Metropolitan Development Commission Regional Center Hearing Examiner (June 11, 2026) Meeting Agenda

STAFF REPORT

Case Number	2025-REG-036
Address (approx.)	222 East Market Street
Location	Center Township, Council District # 12
Petitioner	City of Indianapolis, by Alex Kelley
Zoning	CBD-2 (RC)
Request	Regional Center Approval to provide for a new public plaza west of City Market.

BUILDING ELEVATIONS
05/28/2026

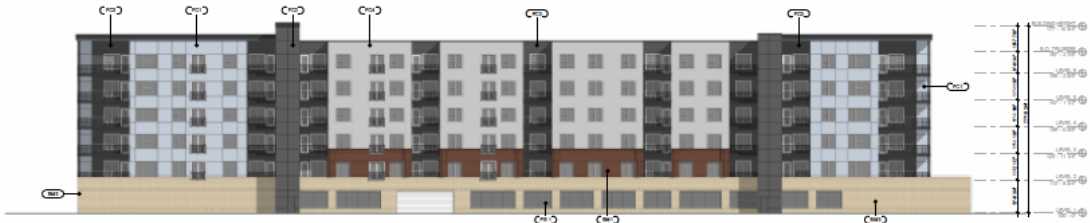
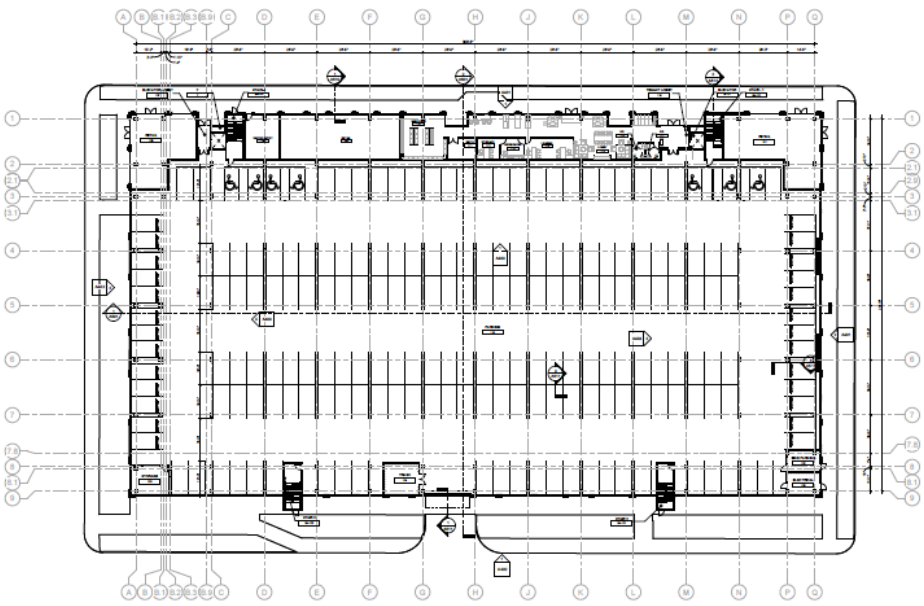
1. Guidelines CA 2.1.4 and CA 2.4.1 require minimum standards for visible light into the building. The submitted plans do not specify the window detail, such as light transmissivity. Detailed window information for the windows adjacent to grade level shall be submitted for planning staff review and approval prior to the issuance of an Improvement Location Permit.

2. A lighting plan was not submitted to the file to identify the location of lighting standards or fixtures. Additionally, a photometric plan has not been submitted to the file. A photometric plan should detail light standards and photometric levels for the site and at each entrance. Lighting must be provided at each entrance and must be dusk to dawn. Only full cut and shielded light standards are permitted with minimum foot-candle power outlined in CA 4.3.2 and CA 4.3.3. Pedestrian areas and entries must be lighted for safety (CA 3.1.3 and CA 4.3.1). A lighting plan should be submitted prior to the hearing to ensure compliance with these requirements. If such a plan is not available, a detailed lighting plan shall be submitted and subject to planning staff review and approval prior to issuance of an Improvement Location Permit.
